RE: Well WD-7

PERMIT TO CONDUCT WELL OPERATIONS

Your proposal to **Rework** well **WD-7**, A.P.I. No. **030-33731**, Section **18**, T. **28S**, R. **29E**, **MD** B. & M., **Round Mountain** field, **Main** area, **Vedder-Walker** pool, **Kern** County, dated **9/13/2012**, received **9/25/2012** has been examined in conjunction with records filed in this office.

Well Remedial/Workover Program

WBD As of : 09/02/07

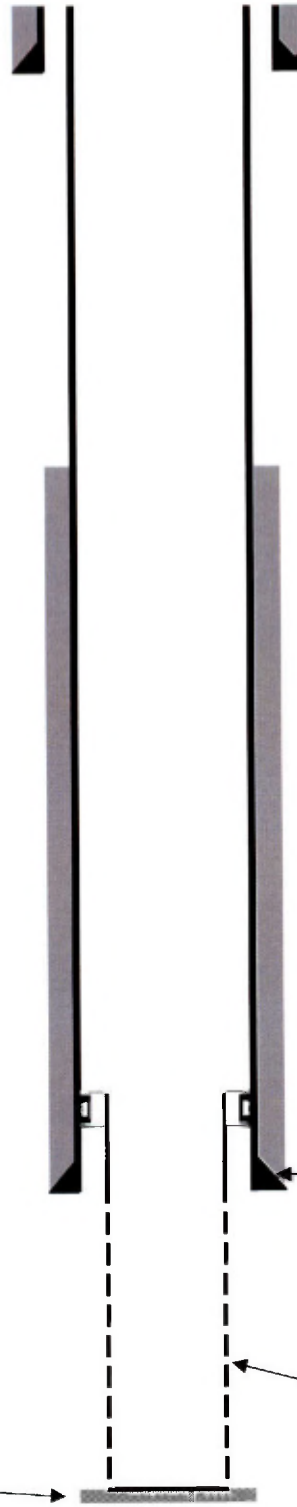
a. Class **II 2M** on the **9 5/8" and 7"** casing.
3. Cement bond logs in program steps 12 and 28 shall be submitted to the division for evaluation prior to proceeding.

4. The **7**" casing is cemented with sufficient cement to fill behind the casing from 2520' to the surface.
5. **THIS DIVISION SHALL BE NOTIFIED TO:**
   a. Witness a pressure test of the **7"** casing prior to drilling out the shoe.
